H-11193

DESCRIPTIVE REPORT

Type of Survey HYDROGRAPHIC

Sublocality Castle Cape and Nikolai Cove

Figure 1 H11193 Survey Limits

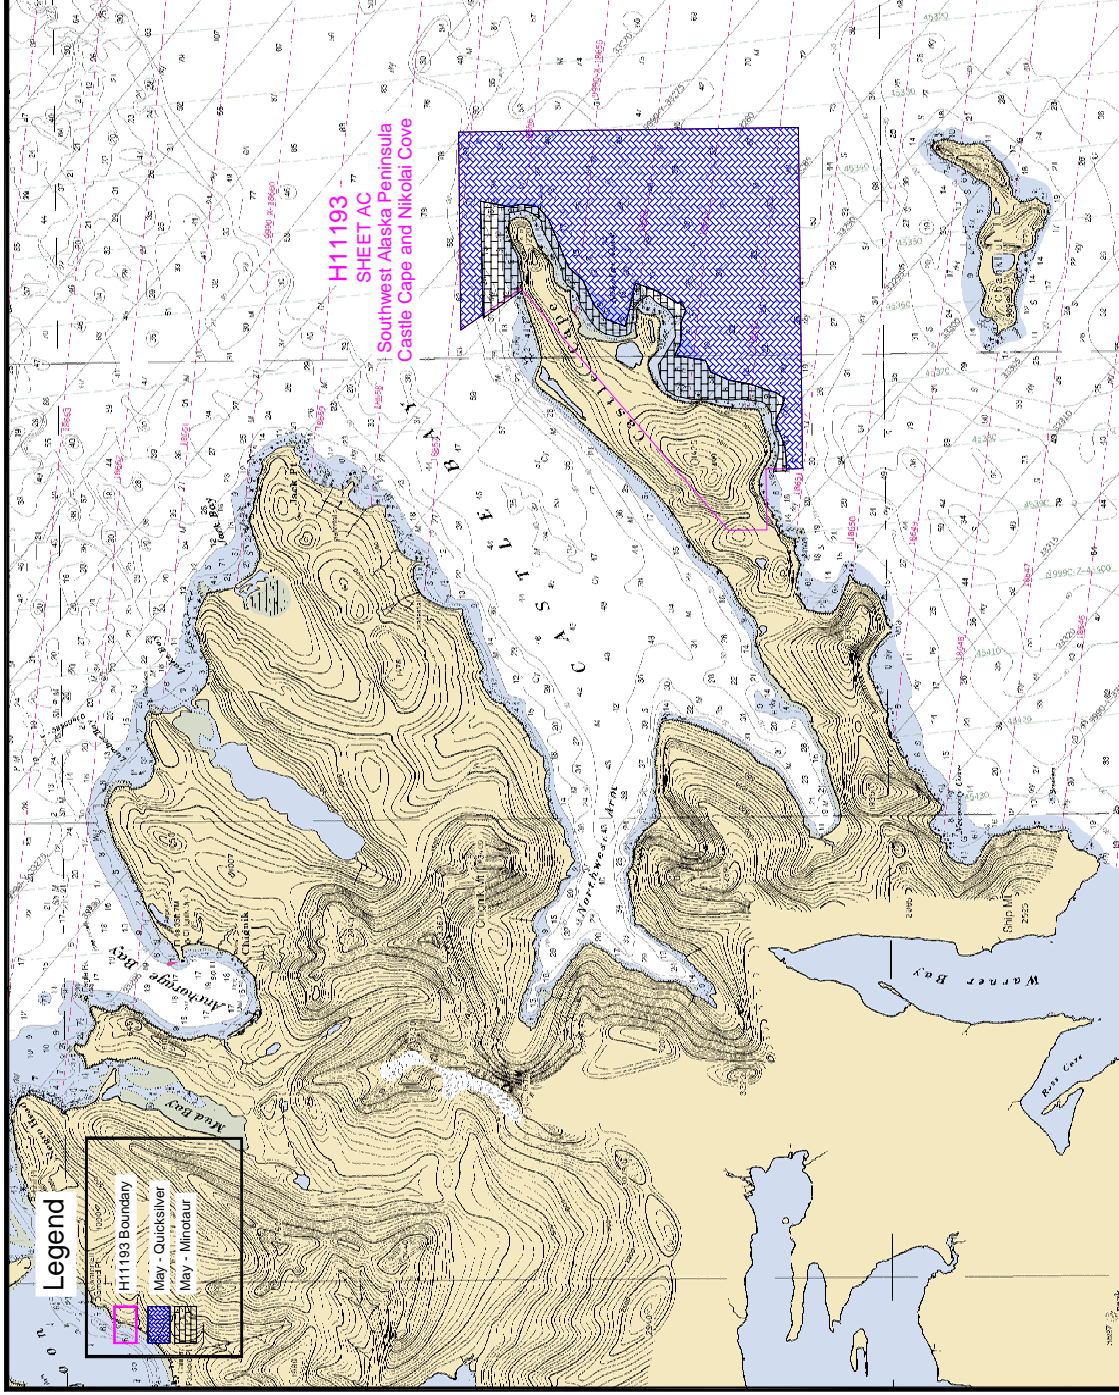
Survey Limits² Task Order # 11 H11193 Sheet AC Scale 1:10,000		
Point #	Positions on NAD83	
	Degrees Latitude (N)	Degrees Longitude (W)
1	56°15'06.996" N	158°09'21.782" W
2	56°14'23.373" N	158°08'28.325" W
3	56°11'54.310" N	158°13'46.769" W
4	56°11'26.624" N	158°13'46.769" W
5	56°11'26.585" N	158°12'27.565" W
6	56°11'00.081" N	158°12'27.565" W
7	56°11'00.042" N	158°05'3.361" W
8	56°15'06.919" N	158°05'03.361" W
9	56°15'06.996" N	158°09'21.782" W ³

² Concur with clarification. The approximate limits of hydrography are:

✚ Lat 56/15/16.9N and Lon 158/9/33.1W

✚ Lat 56/15/16.9N and Lon 158/4/50.0W

✚ Lat 56/10/51.8N and Lon 158/12/42.9W

✚ Lat 56/10/51.8N and Lon 158/4/50.0W

³ Concur with clarification. Point 9 is the same position as Point 1.

Figure 4: Navigation Error With Respect to Slope

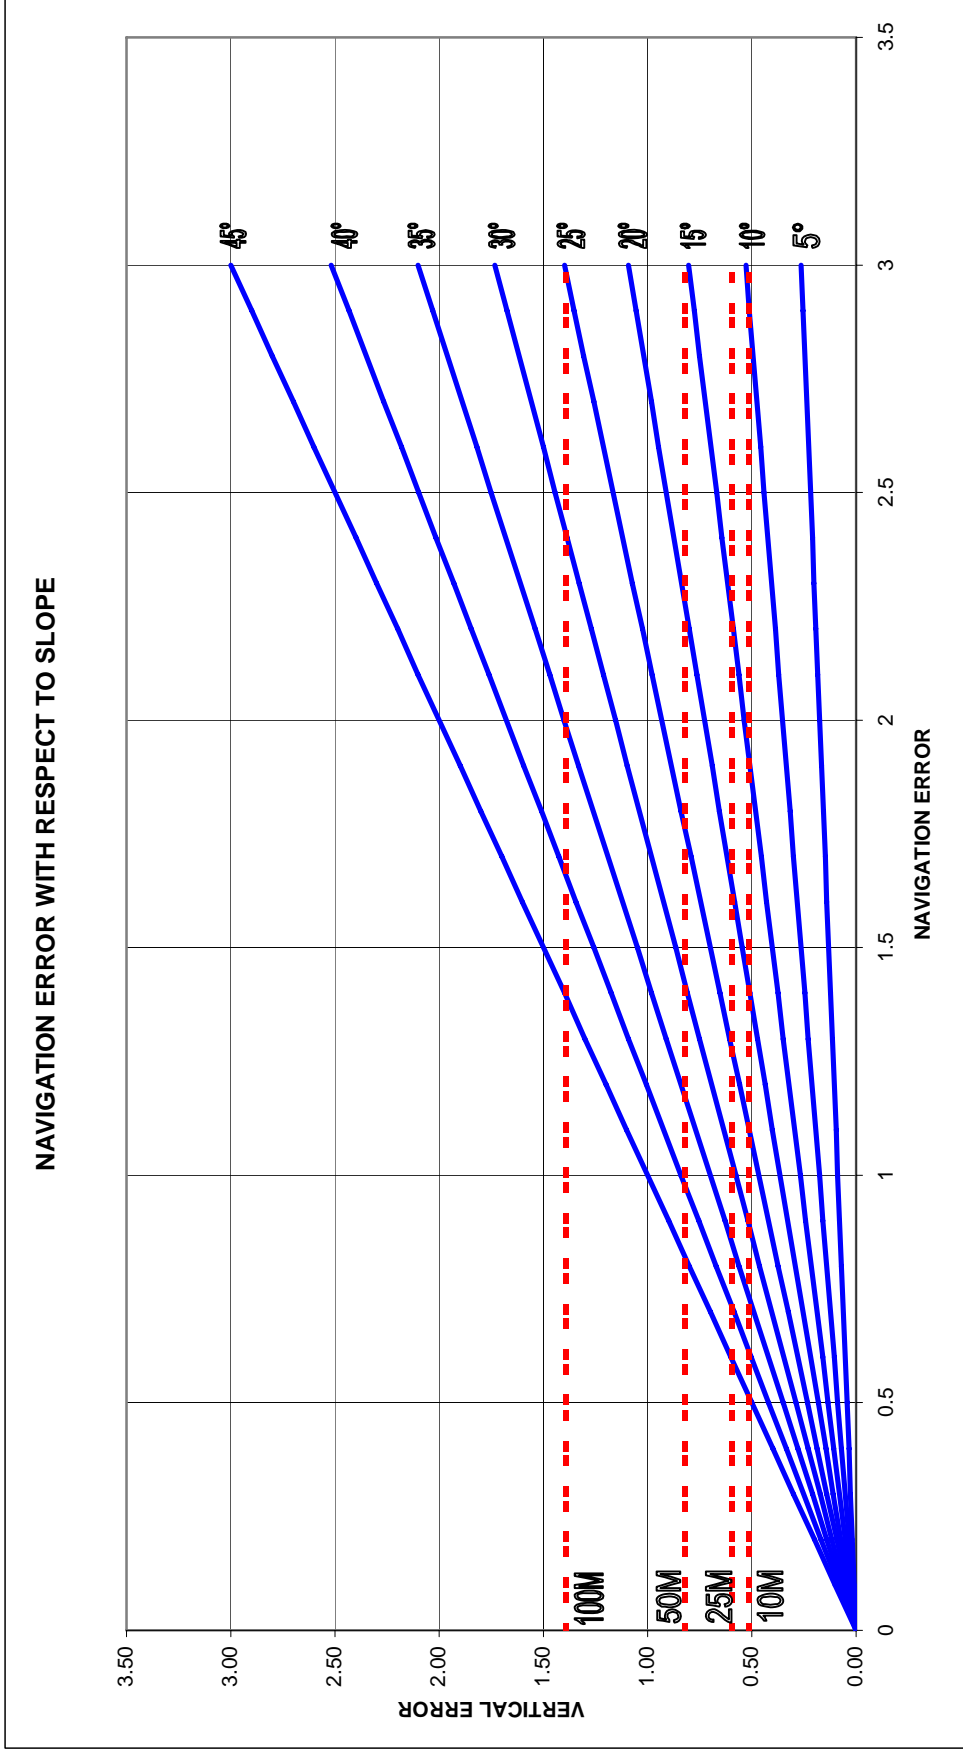
- The accuracy of a typical DGPS unit is between 1 to 3 m, and with the constant coming and going of satellites in these areas; it was not uncommon to get a 1 to 3m- navigation jump. Although this is well within the NOS specifications, Figure 1⁸ shows graphically how navigation error versus⁹ vertical error can rapidly affect the specified accuracy. For example, with a 1.5m navigation error at a water depth of 25m, if the slope of the bottom is greater than 20° then the beams are outside of the 95 percent confidence level.

⁸ Strikethrough ~~1~~, replace with “4”.

⁹ Strikethrough ~~versus~~, replace with “combined with”.

Figure 5 H11193 Survey Junctions

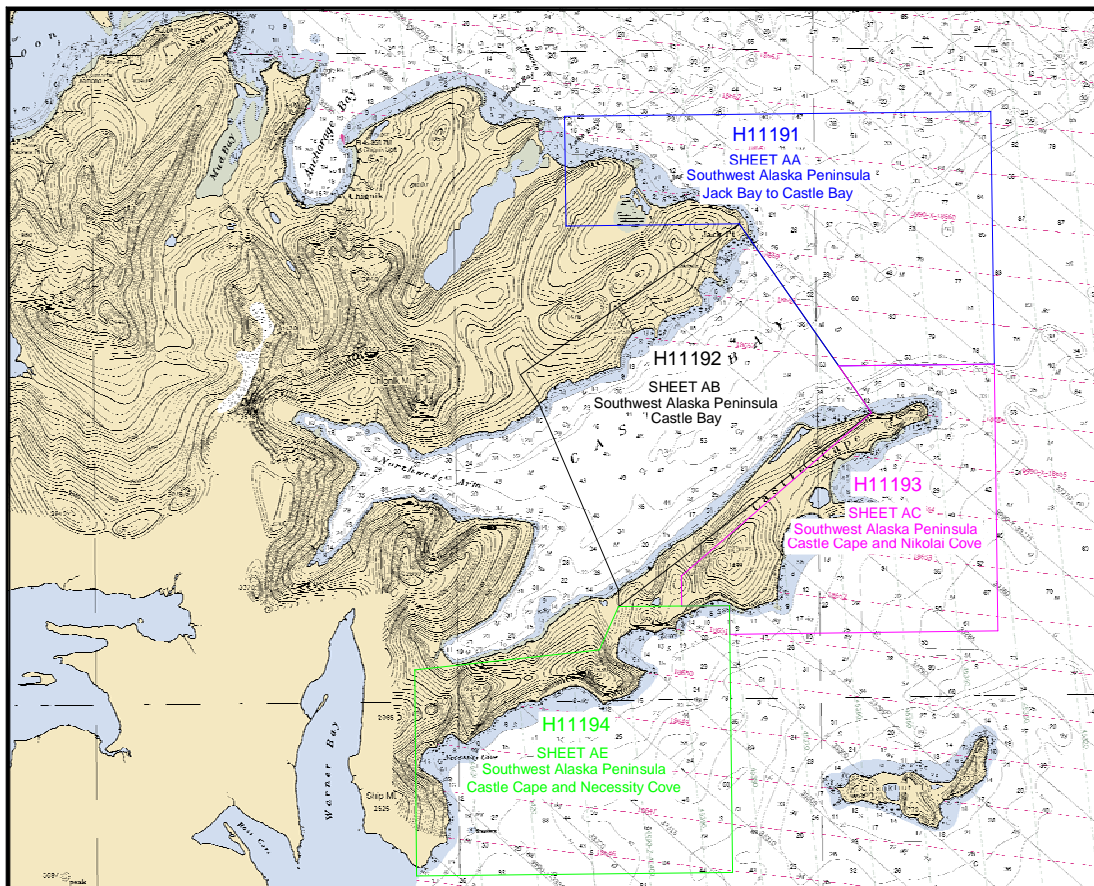
Registry #	Scale	Date	Junction Side
H11191	1:10,000	2003	South ¹²
H11192	1:10,000	2003	Northeast ¹³
H11194	1:10,000	2003	East ¹⁴

The surveys are in agreement along their common borders.¹⁵ The agreement was noted in the field using the 2-meter DTM's created for coverage verification. The conformity is also apparent in their preliminary smooth sheets.

¹² Strikethrough ~~South~~, replace with “North”.

¹³ Strikethrough ~~Northeast~~, replace with “Northwest”.

¹⁴ Strikethrough ~~East~~, replace with “West”.

¹⁵ Concur. In PHB processing, H11193 was also compared at its southern junction with H11459. Common areas showed good correlation. All data sets were considered when compiling contours and soundings to the Hdrawing.

Figure 6 Histogram for 8101 (Quicksilver)

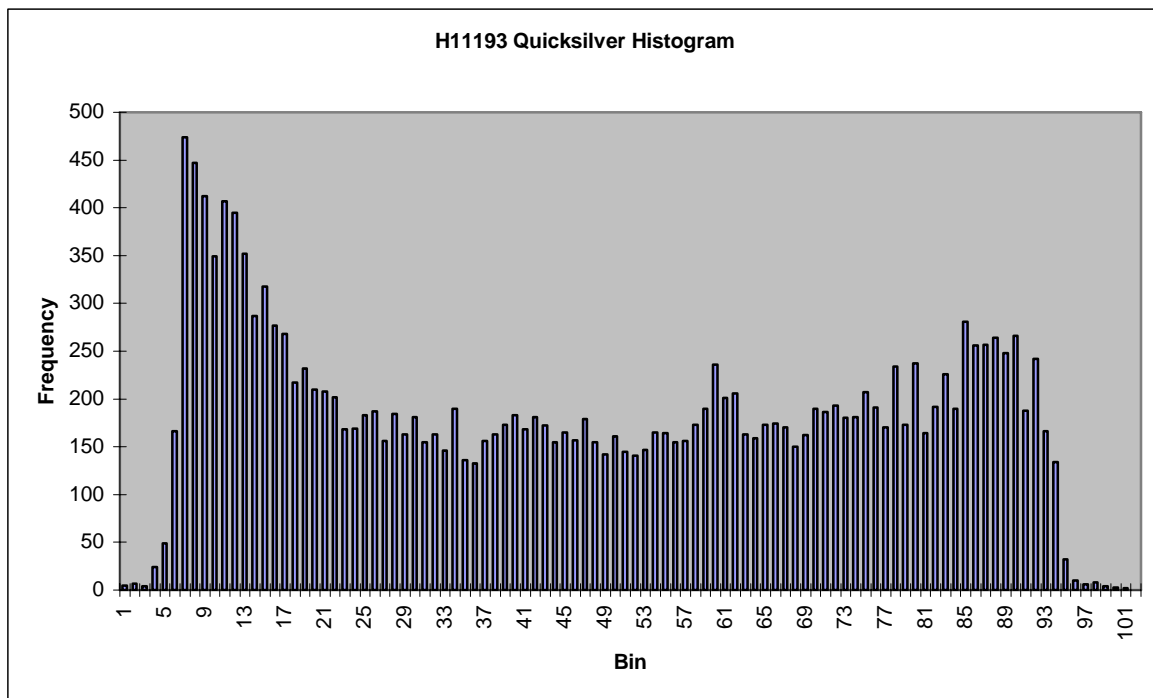
Figure 5¹⁶ Histogram is for the Reson 8101 data collected from May 1, 2003 to June 6, 2003 on the Quicksilver. The histogram is evenly distributed, but there is the increased number of selected soundings on the port side. This is the result of surveying near the shoreline and the simple fact that the outer beams are the shallowest. It is also apparent on these examinations the transition from phase to amplitude detection method of the sonar (around beams 36 and 71) and any errors due to sound velocity.¹⁷ The decrease of selected soundings on the starboard beams is the result of deterioration of data quality on the outer beams, especially in deep water. In most cases set filters were used to flag the outer beams as rejected, but in other cases additional cleaning or filters were used on a line by line bases¹⁸ resulting in fewer selected soundings.

¹⁶ Strikethrough ~~5~~, replace with “6”.

¹⁷ Strikethrough ~~It is also apparent on these examinations the transition from phase to amplitude detection method of the sonar (around beams 36 and 71) and any errors due to sound velocity~~, replace with “the transition from phase to amplitude detection method of the sonar (around beams 36 and 71) and any errors due to sound velocity are apparent”.

¹⁸ Strikethrough ~~bases~~, replace with “basis”.

Figure 7 Histogram for 8101 (Minotaur)

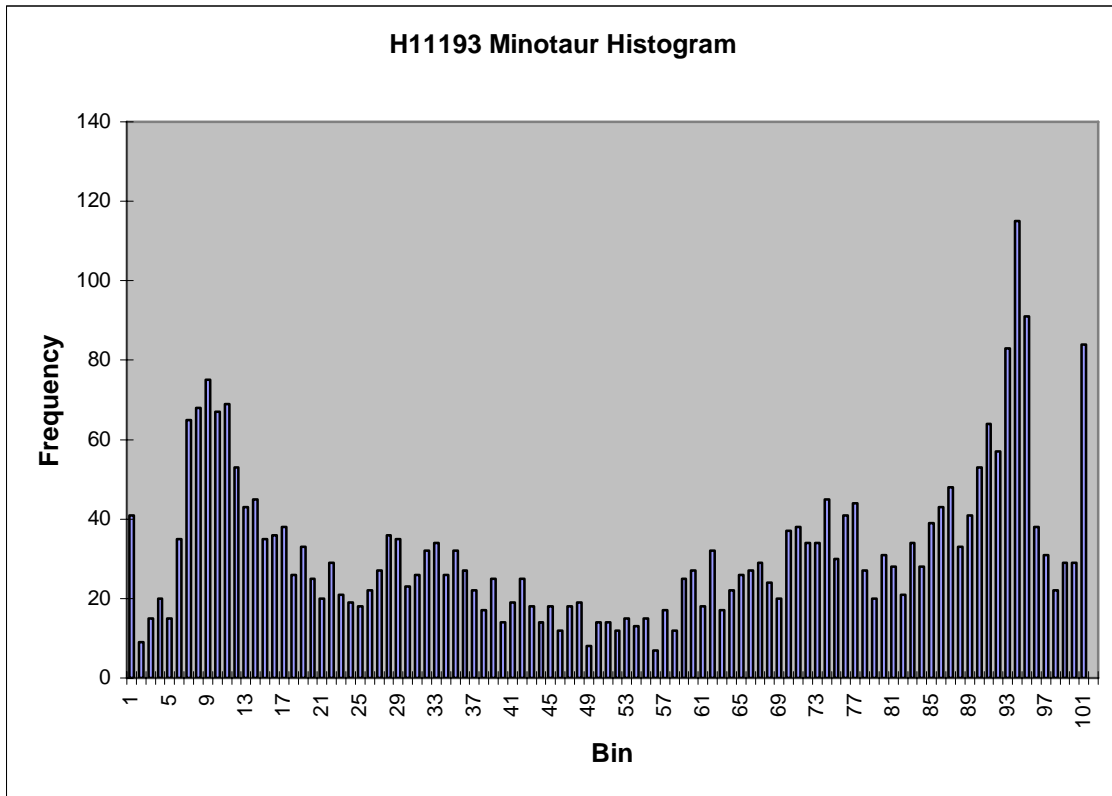
Figure 6¹⁹ Histogram is for the Reson 8101 data, collected from May 1, 2003 to June 6, 2003 on the Minotaur. The histogram shows an increase on selected soundings from the outer beams. This is the result of surveying near the shoreline and the simple fact that the outer beams are the shallowest. Also the majority of lines were run, port beams overlapped with port beams and starboard beams overlapped with starboard beams from the adjacent lines.²⁰ This makes it possible to have higher density data per square meter on the outer edges, leading to a higher chance of sounding selection on the smooth sheet.

This histogram also shows one distinct feature, which is the increase in the number of selected soundings from beams 95 and 101. This does not appear to be the result of equipment failure, survey or processing procedures. Inspection of the smooth sheet reveals trends where those beams are shoaler than the rest of the profiles simply because it is²¹ up slope from all other soundings. The crossline comparisons revealed that these beams²² were within IHO specifications; any differences were only a few centimeters.²³

¹⁹ Strikethrough ~~6~~, replace with “7”.

²⁰ Strikethrough ~~the majority of lines were run~~, replace with “in the majority of lines run”.

²¹ Strikethrough ~~it is~~, replace with “they are”.

²² Strikethrough ~~beams~~, replace with “soundings”.

²³ Survey data is acceptable for charting.

Figure 8 Comparison of Contours

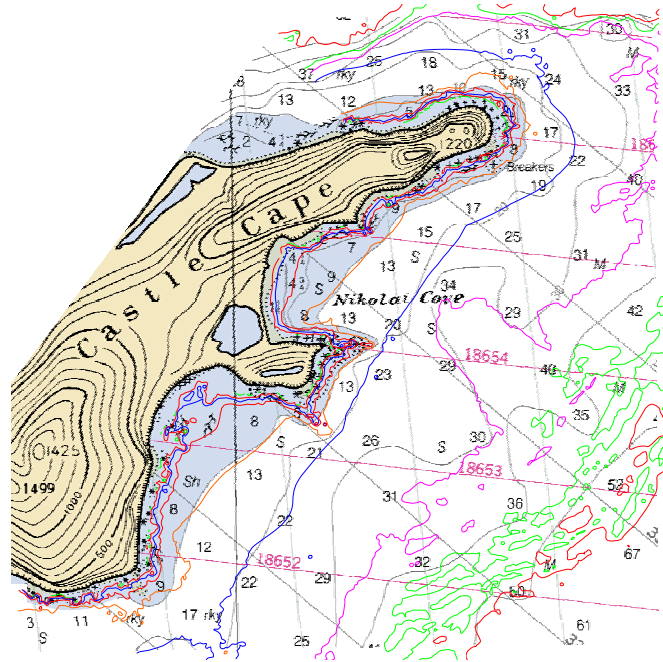
The near shore contours agree with the existing chart 16566, but as illustrated in Figure 8 below, the contours from H11193 bring forth much more detail of the bottom topology.³⁸

- ³⁶ Filed with the project reports.
- ³⁷ ~~Strikethrough Danger to Navigations~~, replace with "Dangers to Navigation". Attached to this report.
- ³⁸ Concur with clarification. The nearshore contours are often in agreement with charted contours. Note that some errors occurred in the depiction of contours on the smooth sheet. Errors have been corrected on the Hdrawing. Chart contours as generalized on the Hdrawing.
